UNITED STATES PATENT AND TRADEMARK OFFICE

Office Action Summary	Application No. 10/808,967	Applicant(s) NIWA ET AL.	
	Examiner Lan Nguyen	Art Unit 3683

Title: ANTI-SQUEAL SHIM STRUCTURE AND A DISC
BRAKE APPARATUS COMPRISING THE SAME
Inventor(s): Takahiro NIWA, et al.
Serial No.: 10/808 967
Docket No.: 4218.P0001US

Replacement Sheet

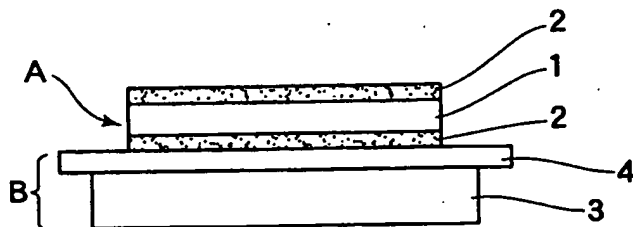
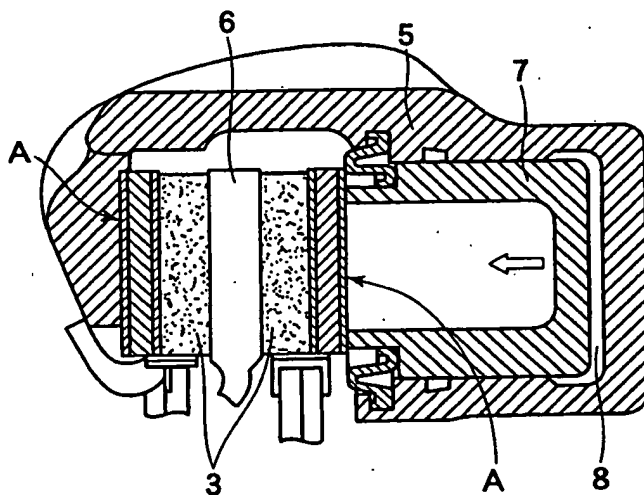
1. The drawings were received on 9/12/05. These drawings are approved.

approved
XLN
11/25/05
